**THE SHELBY COUNTY COMMISSION
NORTH-SOUTH CONNECTOR
PHASE 2**

ADDENDUM NO. 2

1. Re: Sheet 7 Plan AND Profile

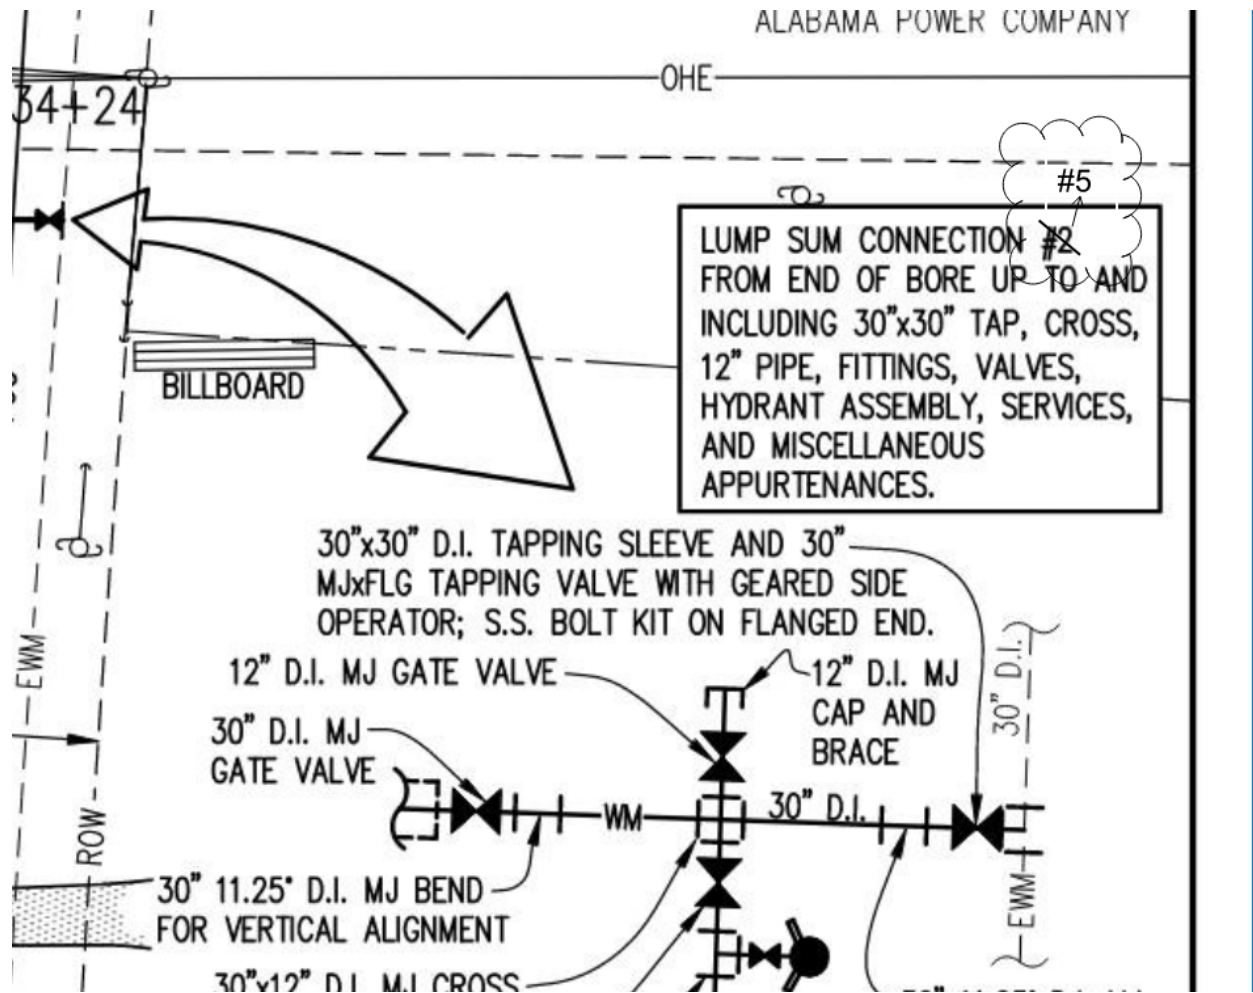
Revision: Lump Sum Connection #2 should read Lump Sum Connection #5 – see snippet below.
